April 4, 2012

**Environment Canada - Information Request
Responses - Gahcho Kué Project Environmental Impact Review**

GAHCHO KUÉ PROJECT ENVIRONMENTAL IMPACT STATEMENT
INFORMATION REQUEST RESPONSES

Figure EC_1-1a

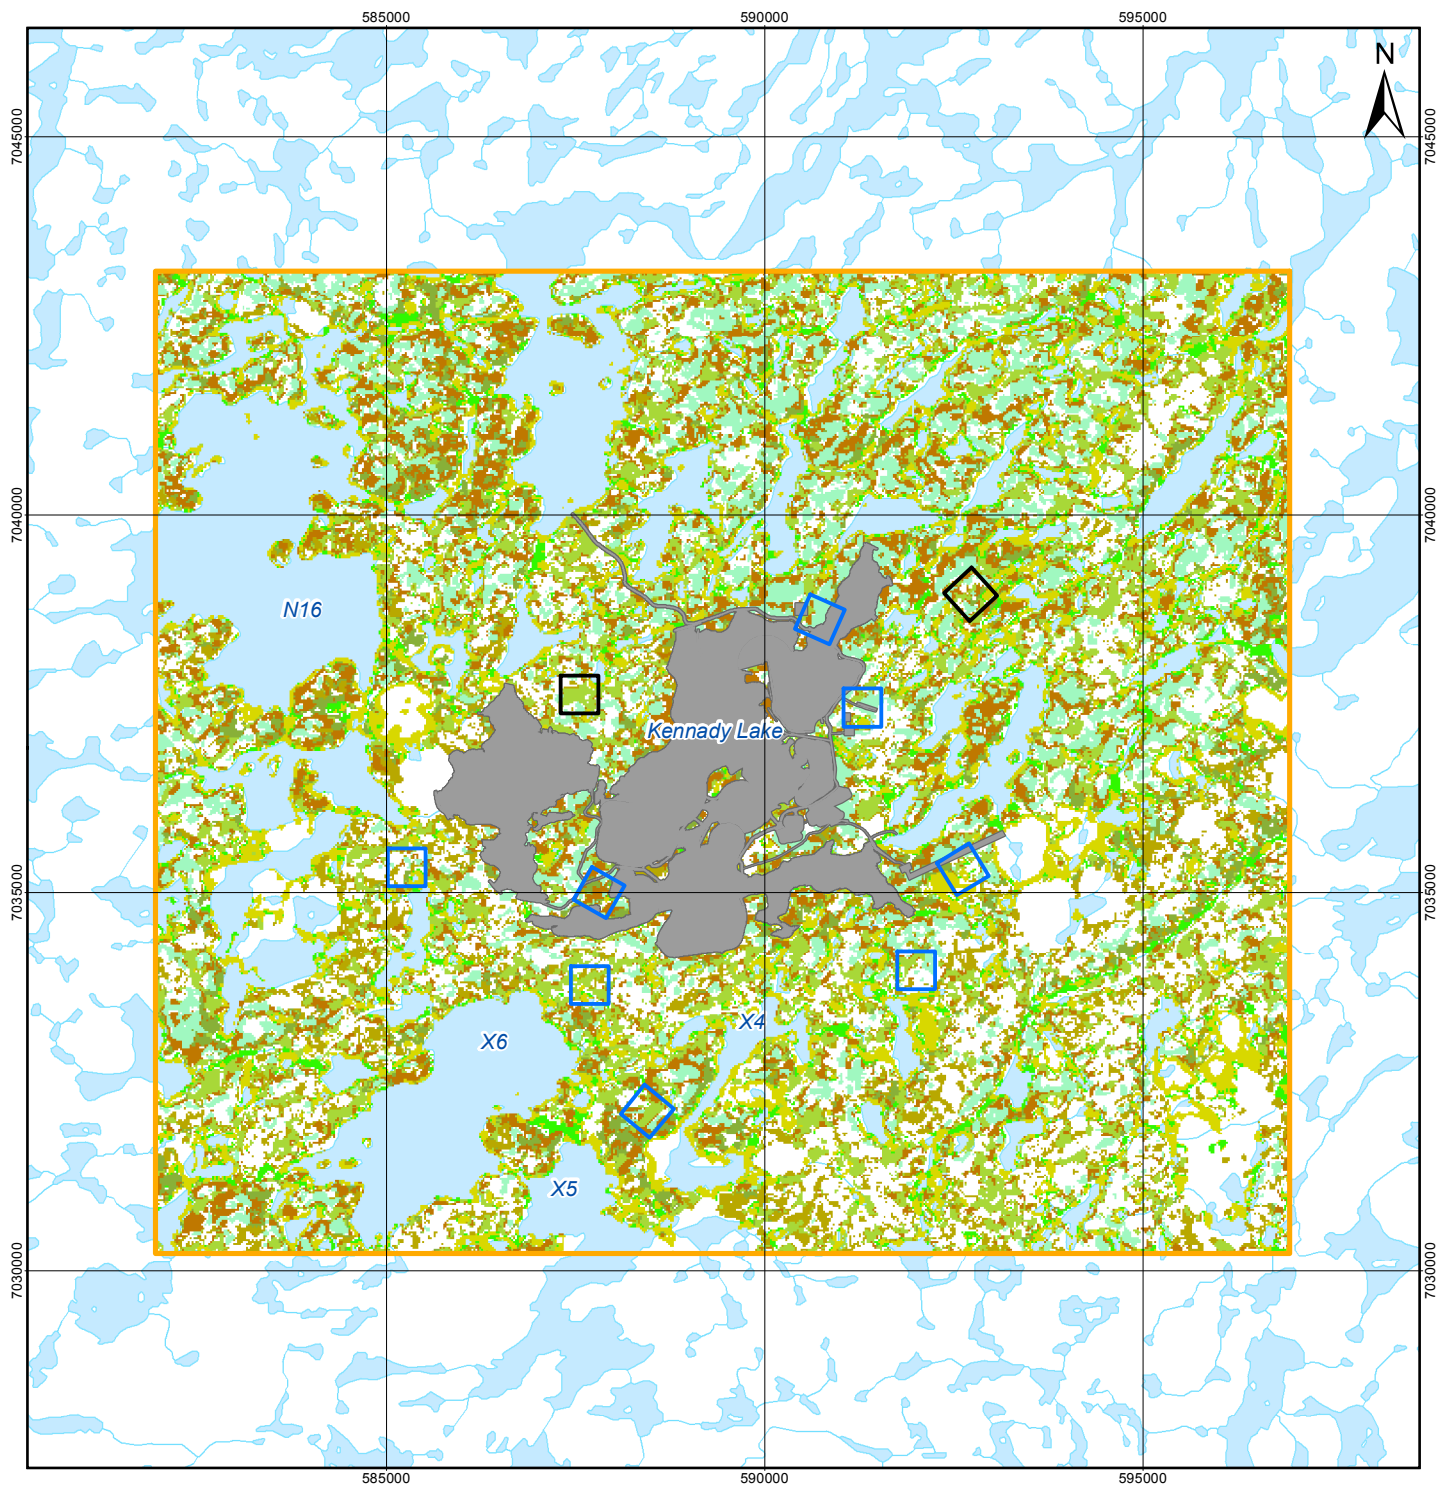
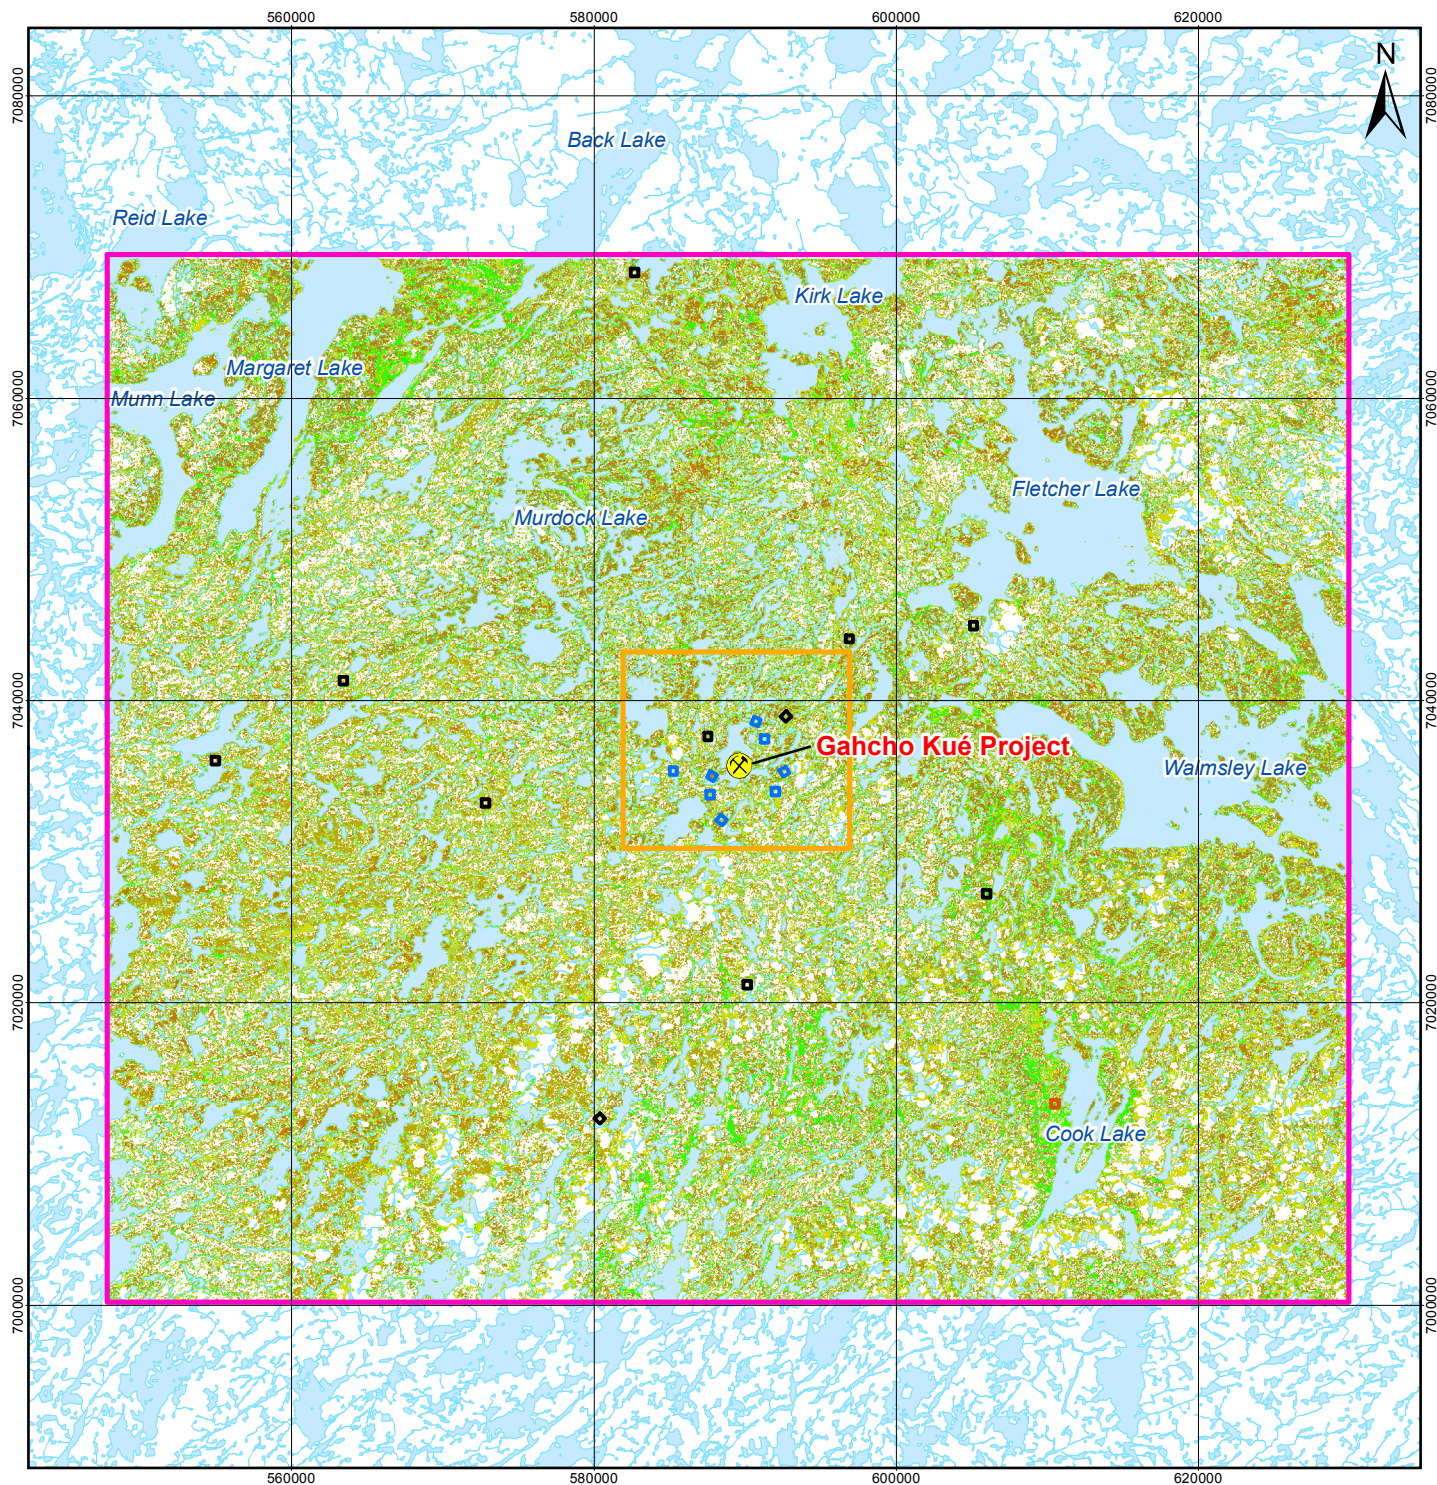
1. An explanation of whether plot locations were randomly assigned or pre-selected on the basis of habitat composition.
2. Two maps, one at the scale of the local study area (LSA) and one at the scale of the RSA showing the distribution of the three broad habitat categories used to classify Upland Bird plots - Heath Tundra, Sedge Wetlands and Riparian Habitat used for bird plots in the LSA before project implementation and after project implementation. Please include the boundaries of Upland Bird plots on these maps.

2. Figures EC_1-1a and EC_1-1b show the location of upland breeding bird survey plots before and after construction of the Project in the local study area (LSA). The primary habitat types contained within heath tundra and sedge wetlands plots are also illustrated. Figure EC_1-2 illustrates the distribution of heath tundra, sedge wetlands, and riparian plots across the regional study area (RSA). The distribution of primary habitat types comprising these plots is also provided.

Figure EC_5-1

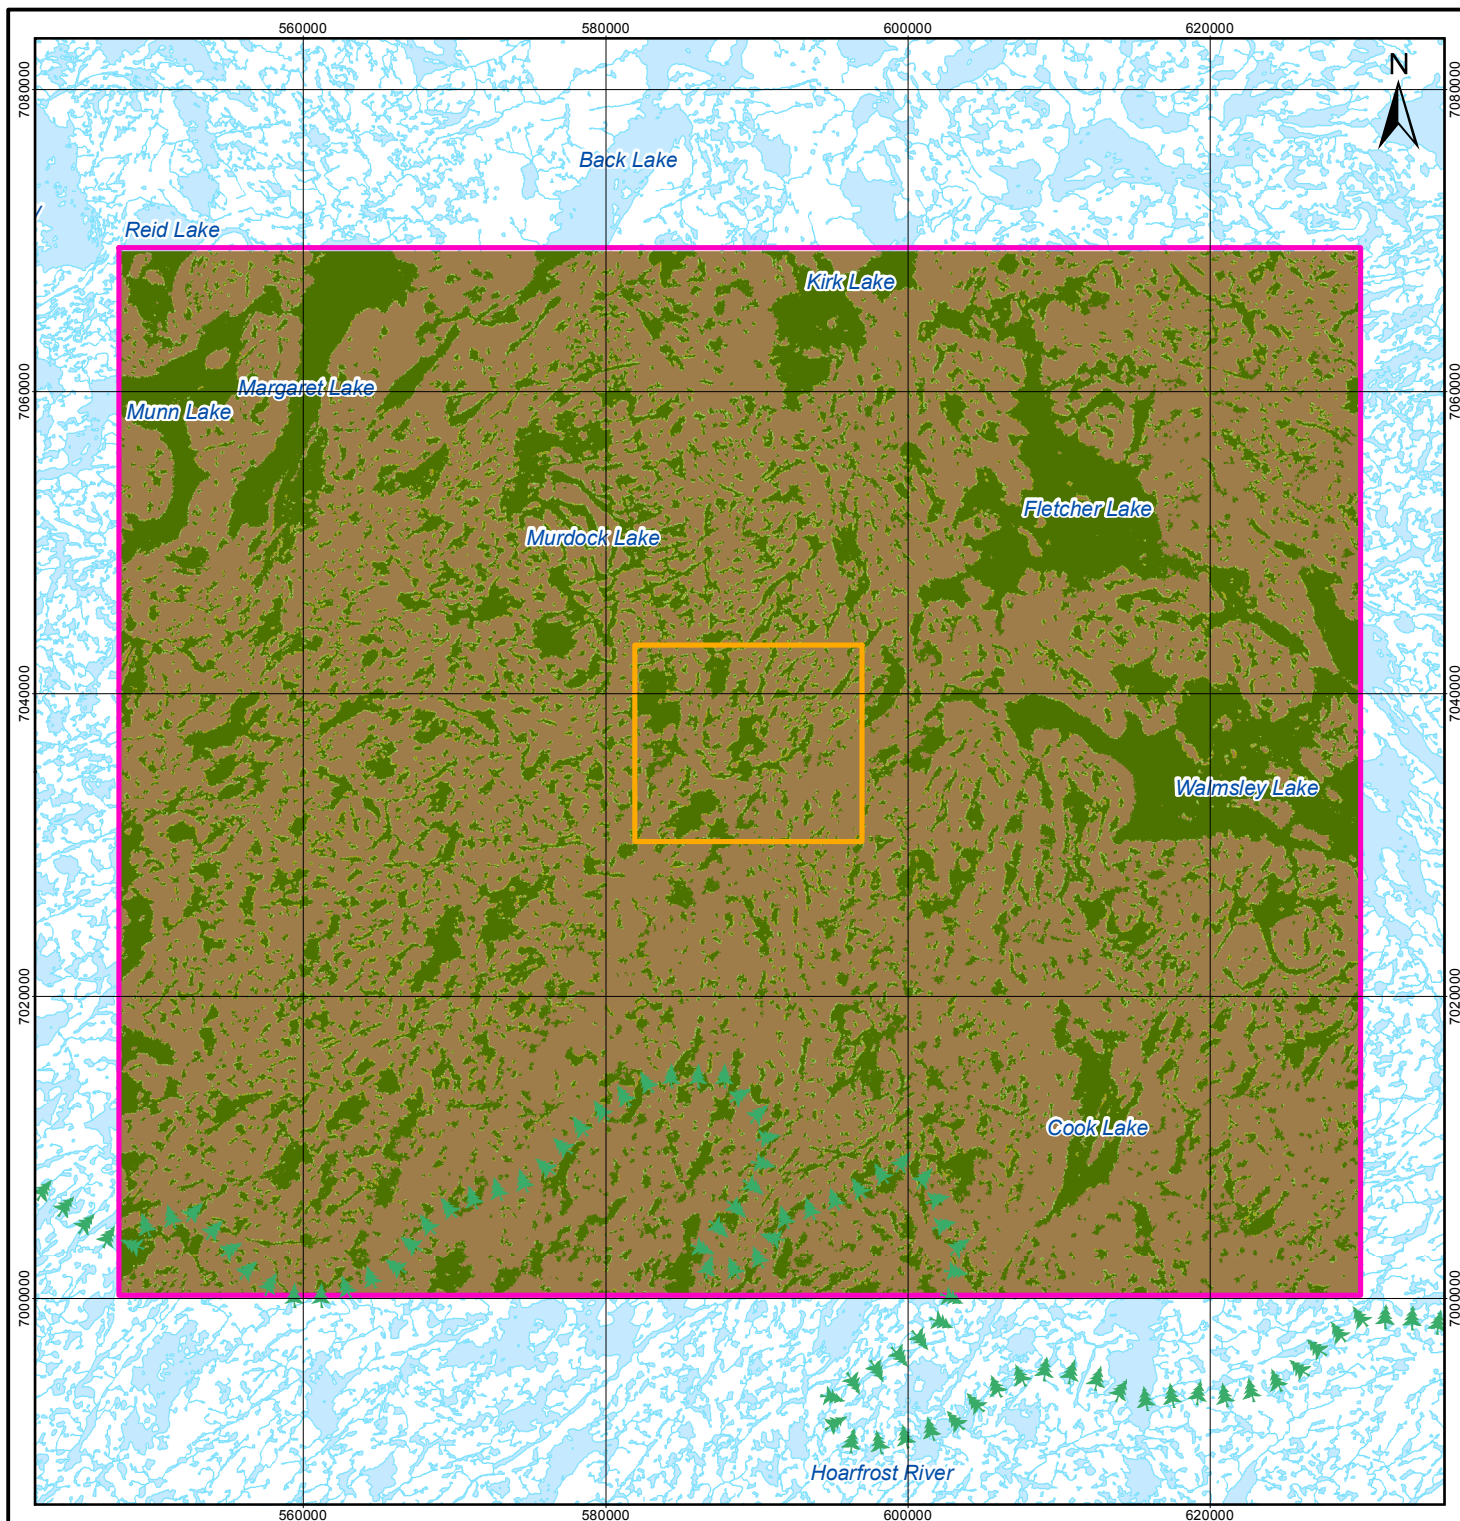
1. Clarify how areas of Shallow and Deep water within lakes and other waterbodies were considered in the HSI model.
2. If areas within waterbodies >100 m from the shoreline were considered as Poor suitability habitat in the model, please provide a justification for this assumption.
3. For comparison, please provide a re-calculation of changes in availability of High suitability habitat in the RSA from active disturbances associated with the project and other foreseeable developments using an HSI model that considers all areas within waterbodies as initially High suitability habitat.

decrease in high and good quality habitat from the Project and other previous, existing and future developments was calculated to be 1.4% (De Beers 2010, Table 11.12-23; Section 11.12.5.2.2). Habitat suitability modelling for reference conditions and the future case are shown in Figure EC_5-1 and Figure EC_5-2, respectively.
